1.I. VIEWPACK FOR 08/10/2020

Proposed HDC Minutes for July 6, 2020

14. Martha Morris 06-1233 9 Dennis Drive Roof top solar 67-366 ACK Smart
 Voting Pohl, Coombs, Camp, Oliver, Welch
 Alternates None
 Recused None
 Documentation Architectural elevation plans, site plan, photos, correspondence, and manufacturer spec sheet.
 Representing Tim Carruthers, ACK Smart
 Public None
 Concerns (time) Carruthers – Presented project; read letter from the owner also signed by a neighbor; circa 1981.

PV 01

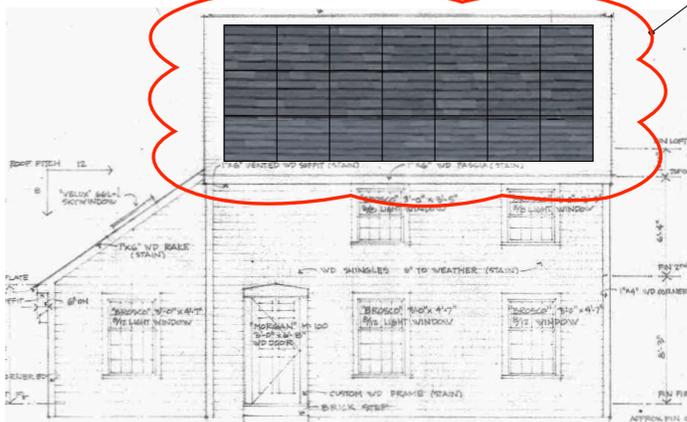
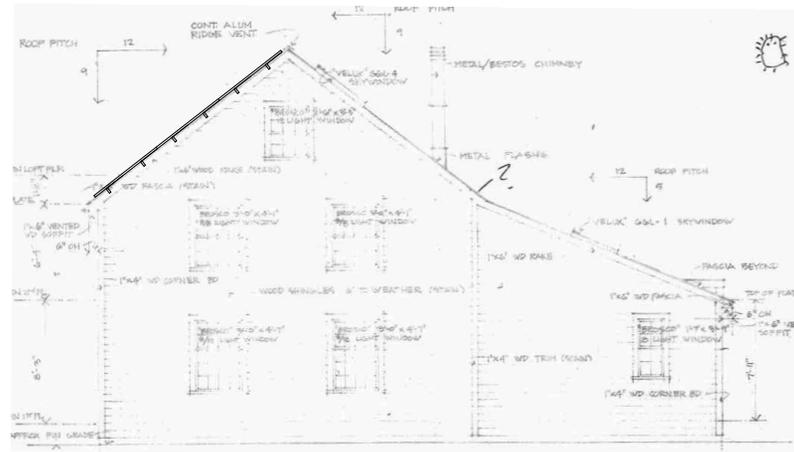
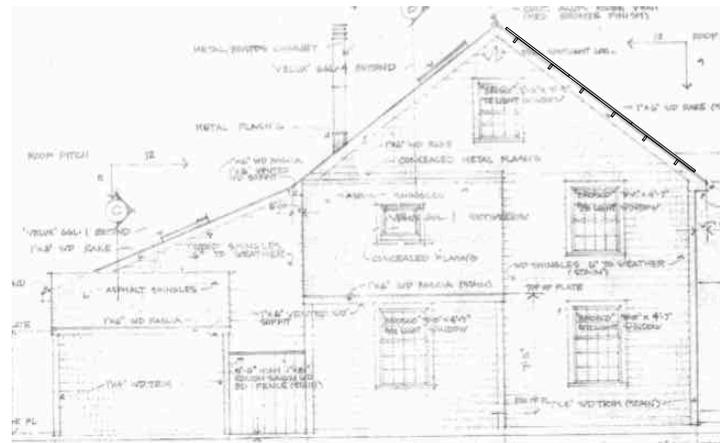
Oliver – She's concerned about the visibility from the cul de sac despite the mitigating circumstances. West elevation has a shed roof; asked if that might provide sufficient power for the structure.

Camp – This is the same situation as Meadow Lane and it doesn't enhance the neighborhood.

Coombs – This flies in the face of our guidelines; there's no way it can be disguised. We approved a land array at 300 Polpis Road that works very well; you need to use some imagination.

Welch – Agrees with what's been said. This doesn't meet the guidelines; where we can disguise with screening, we try to make exceptions on a case-by-case basis; this would be hard.

Pohl – It appears from the photos there is sufficient vegetation to screen the house from most angles except the front. Asked about the east-facing roof.

Motion **Motion to Hold for revisions. (Coombs)**
